State of New Mexico
Energy, Minerals and Natural Resources

WELL API NO. 30-025-34631
5. Indicate Type of Lease STATE [] FEE [X]
6. State Oil & Gas Lease No.
7. Lease Name or Unit Agreement Name SHELL LUSK ANB
8. Well Number 2
9. OGRID Number
10. Pool name or Wildcat BIG DOG; STRAWN, SOUTH &

SUNDRY NOTICES AND REPORTS ON WELLS
(DO NOT USE THIS FORM FOR PROPOSALS TO DRILL OR TO DEEPEN OR PLUG BACK TO A DIFFERENT RESERVOIR. USE "APPLICATION FOR PERMIT" (FORM C-101) FOR SUCH PROPOSALS.)
1. Type of Well: Oil Well [X] Gas Well [] Other []
2. Name of Operator CONTANGO RESOURCES, INC
3. Address of Operator 717 TEXAS AVE, SUITE 2900, HOUSTON, TX 77002
4. Well Location Unit Letter E : 1,950 feet from the NORTH line and 350 feet from the WEST line
Section 11 Township 16S Range 35E NMPM County LEA
11. Elevation (Show whether DR, RKB, RT, GR, etc.) 3,990' GR

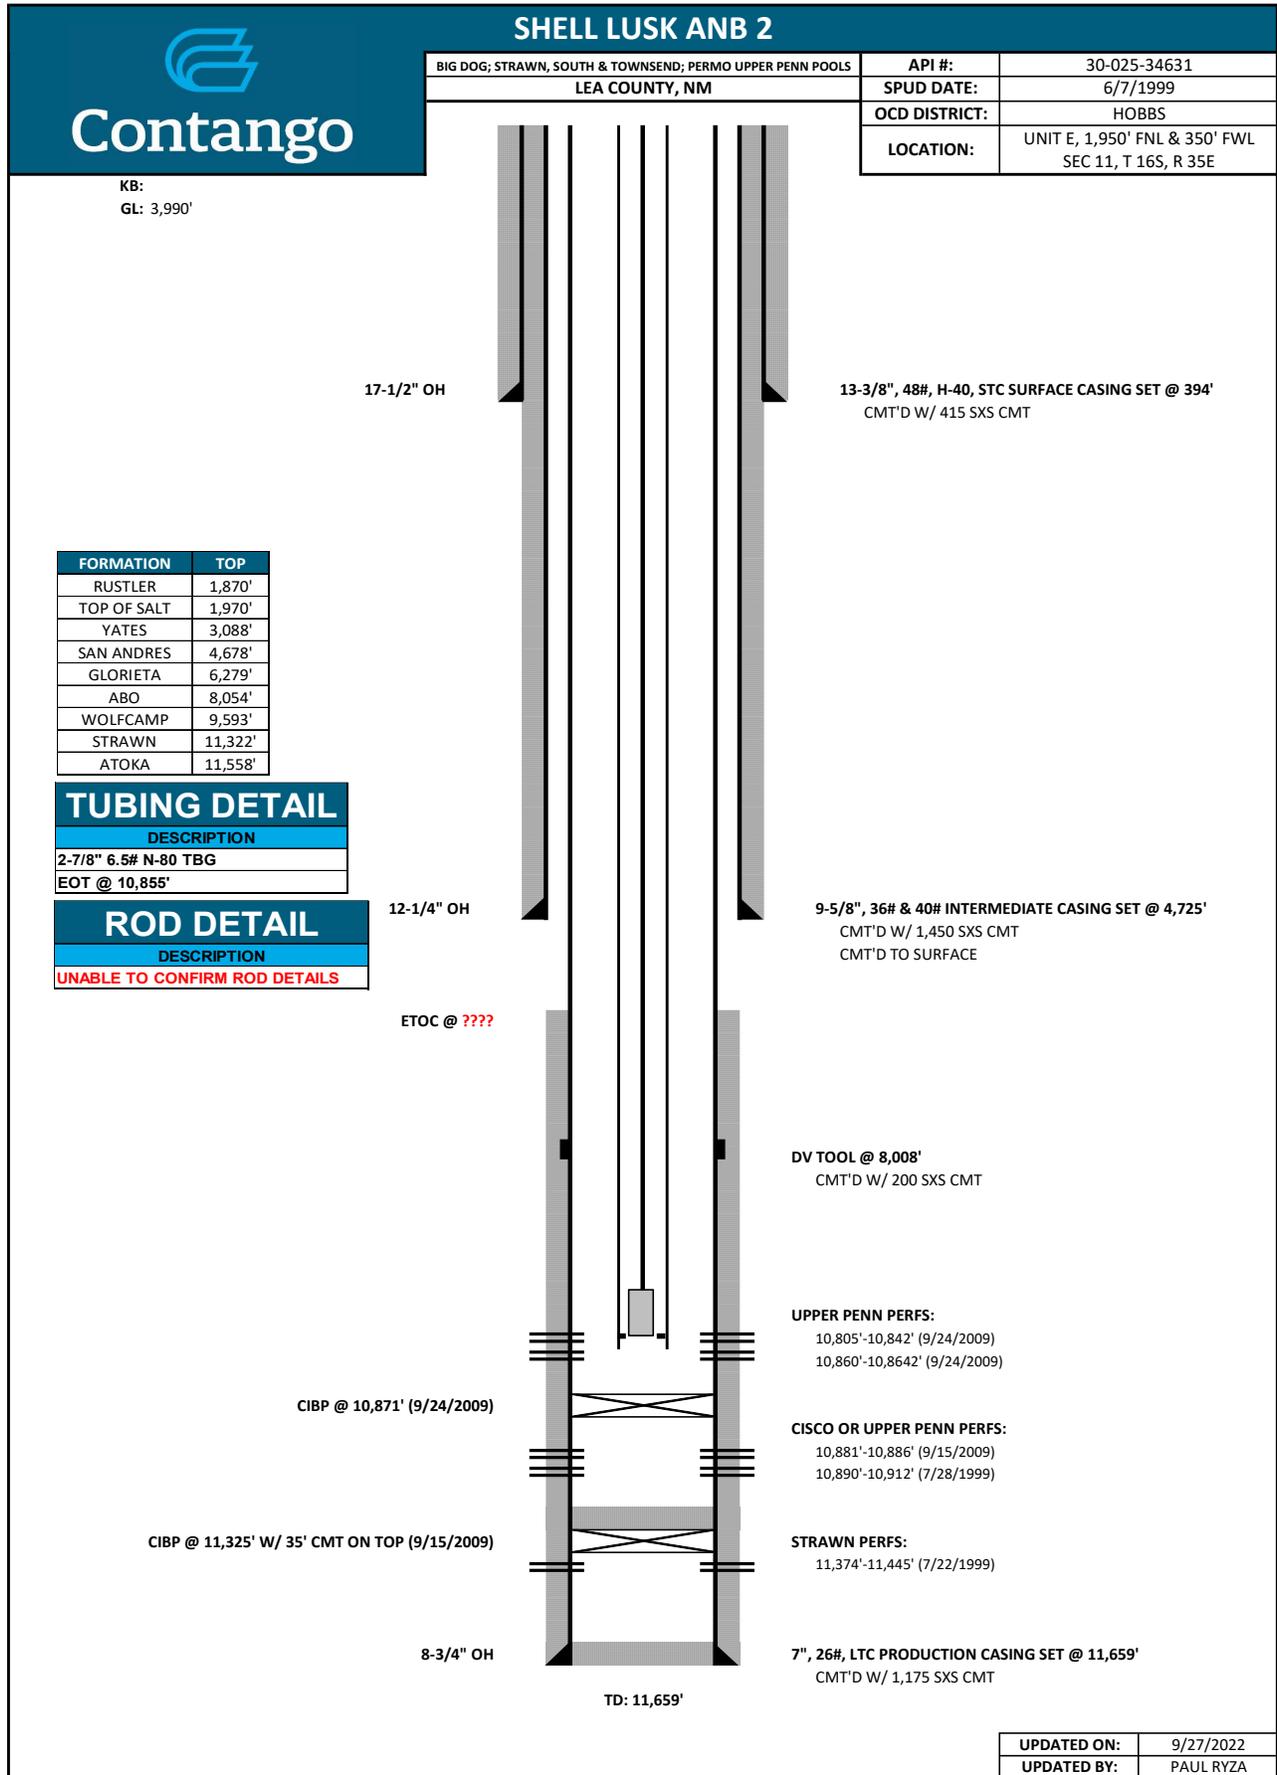
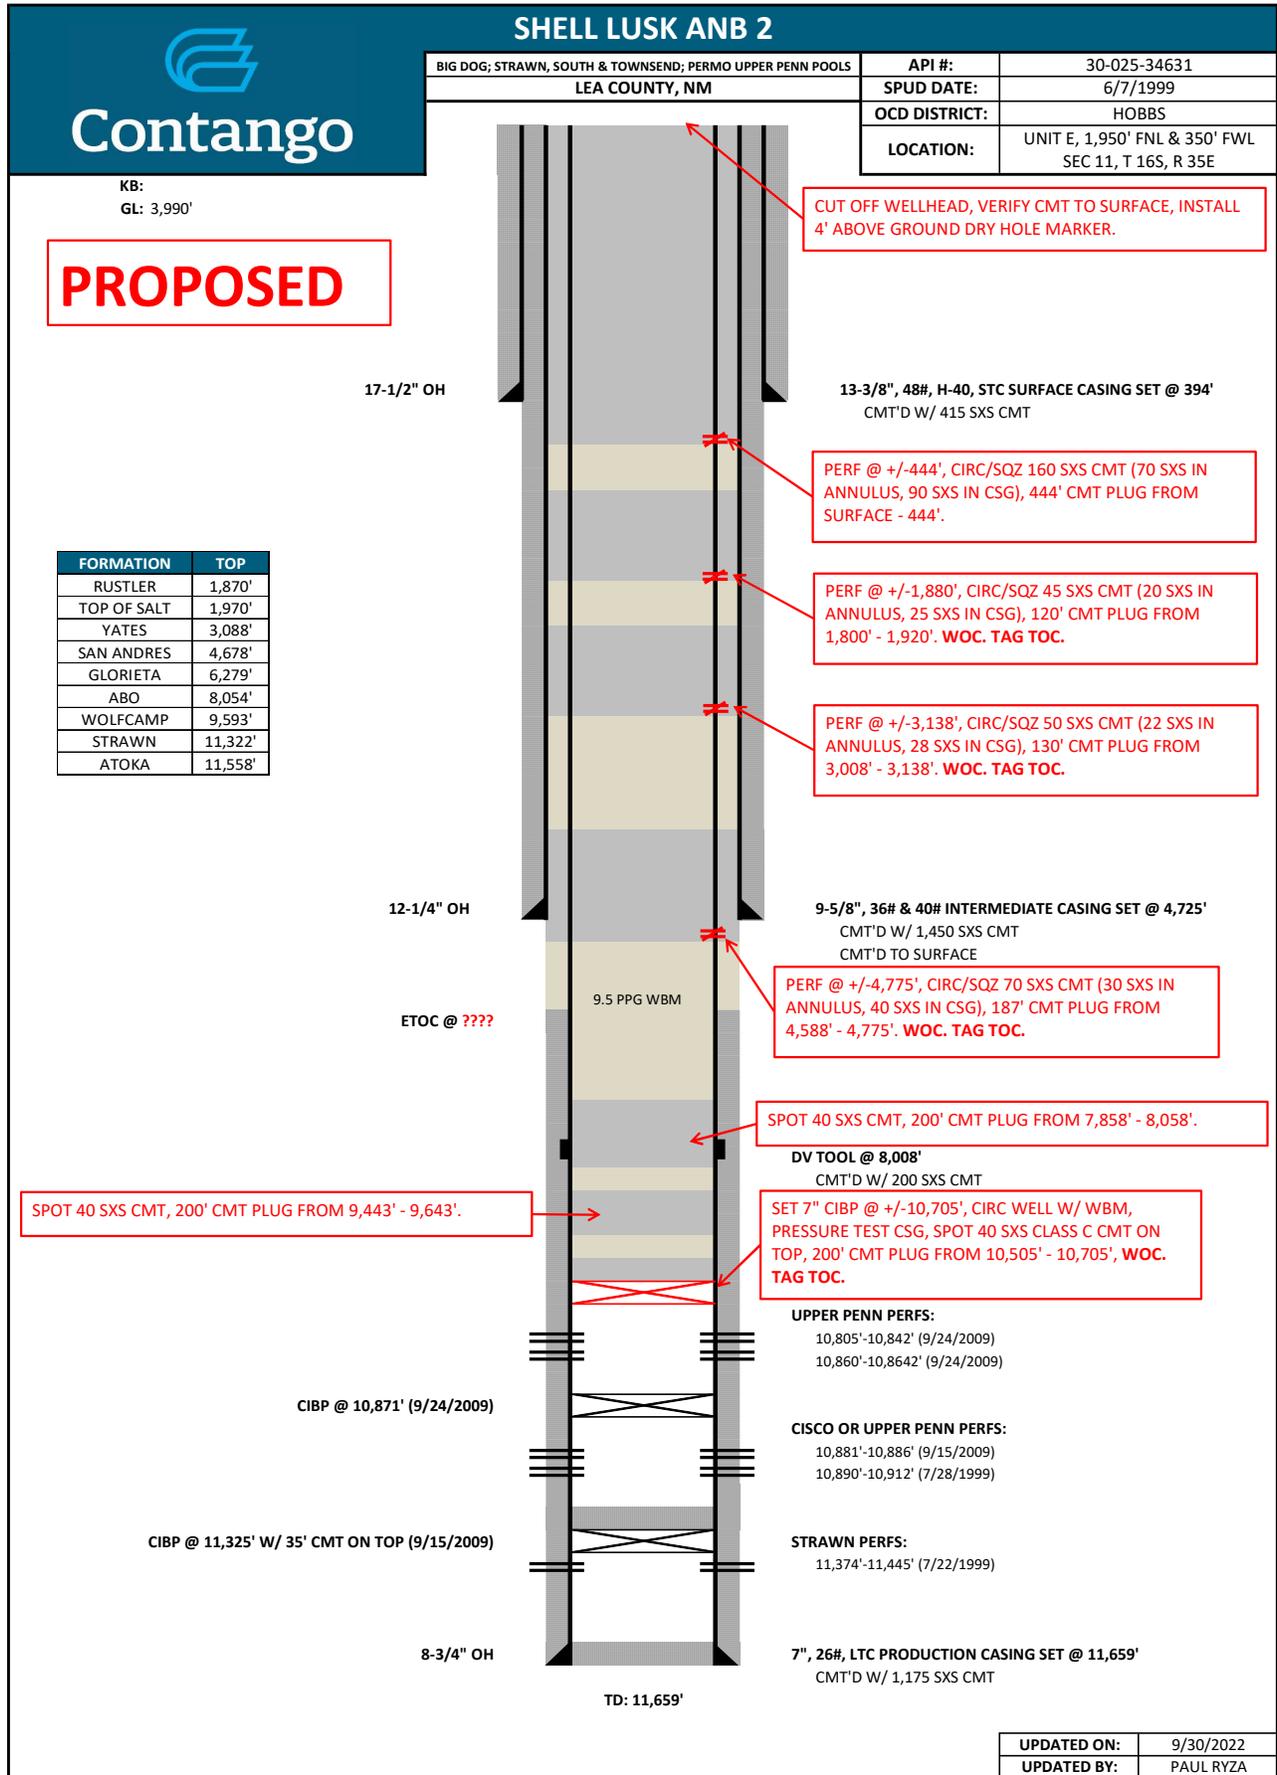
Run CBL

****SEE ATTACHED COA's****

MUST BE PLUGGED BY 11/3/2023
